APPLICATION NO.	FILING DATE	FIRST NAMED INVENTOR	ATTORNEY DOCKET NO.	CONFIRMATION NO.
10/561,352	02/15/2007	Roland Oehmann	7742.3011.001	4020
23399 REISING ETH	7590 05/05/201 INGTON P.C.	EXAMINER		
PO BOX 4390		DOAK, JENNIFER L		
TROY, MI 480	<del>99-439</del> 0		ART UNIT	PAPER NUMBER
			2872	
			MAIL DATE	DELIVERY MODE
			05/05/2010	PAPER

Office Action Summary		Application	plication No. Applicant(s)				
		10/561,35	2	OEHMANN, ROLAND			
		Examiner		Art Unit			
		Jennifer L.	Doak	2872			
The MAILING DATE of this communication appears on the cover sheet with the correspondence address Period for Reply							
A SHORTENED STATUTORY PERIOD FOR REPLY IS SET TO EXPIRE 3 MONTH(S) OR THIRTY (30) DAYS, WHICHEVER IS LONGER, FROM THE MAILING DATE OF THIS COMMUNICATION.  - Extensions of time may be available under the provisions of 37 CFR 1.136(a). In no event, however, may a reply be timely filed after SIX (6) MONTHS from the mailing date of this communication.  - If NO period for reply is specified above, the maximum statutory period will apply and will expire SIX (6) MONTHS from the mailing date of this communication.  - Failure to reply within the set or extended period for reply will, by

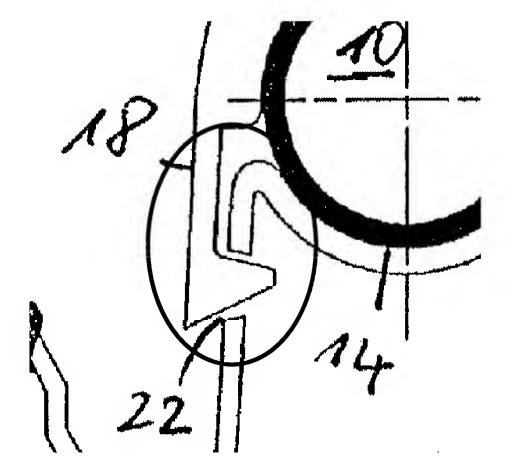
Regarding claim 25, Lang discloses an outside rear view mirror assembly (Title) for a motor vehicle, said outside rear view mirror assembly comprising: a mirror housing (Fig. 2) including a circumferential lateral wall (i.e., as defined by the circumscribing edge of 4) defining an opening (i.e., wherein the mirror resides), an insertion opening (22), and a back wall (5); a mirror mounting bracket (18) fixedly securable to the motor vehicle (i.e., via 22 and 4) and insertable into said mirror housing (i.e., within the housing circumference) through said insertion opening, said mirror mounting bracket (18) including a catch recess (i.e., the part of the clip recessed behind the pointed projection that allows connection with 22; see circled portion of Fig. 2 below);

and a snap-in tongue (i.e., the clips extending from 5) defining a free end and extending out from said back wall (i.e., interior wall of 5) within said mirror housing for positive locking engagement with said catch recess (see Fig above; moreover, this limitation constitutes intended use) engaging said mirror mounting bracket (i.e., via 4) when said mirror mounting bracket is inserted into said mirror housing to lock said mirror mounting bracket therein (Fig. 2) such that said mirror housing is fixedly securable to the motor vehicle (although the Lang does not specifically disclose the claimed attachment to a motor vehicle, this feature is seen to be an inherent teaching of that device since it is disclosed that the invention is a rearview mirror for

Regarding claim 27, Lang further discloses that said mirror mounting bracket includes a catch recess (Fig. 2) to receive said snap-in tongue (Fig. 2) therein to lock said mirror mounting bracket in place (Fig. 2), and wherein said snap-in tongue includes a catch piece (i.e., the projection from the tip) at said free end thereof to engage said catch recess.

Regarding claim 28, Lang further discloses that said mirror mounting bracket includes a positive locking component (i.e., the folded back section of 4 including the recess) extending out from said mirror mounting bracket to guide said mirror mounting bracket as it is inserted into said mirror housing (Fig. 2).

Regarding claims 30 and 31, Lang further discloses said positive locking component includes a stop (i.e., the uneven portion of 4 just beyond the clip of 5) for abutting said insertion tunnel preventing said catch piece from moving past said catch recess (Fig. 2); that said catch recess includes an angled surface (i.e., the angled nature of the surface may be seen in the figure) to abut and engage said catch piece (Fig. 2).
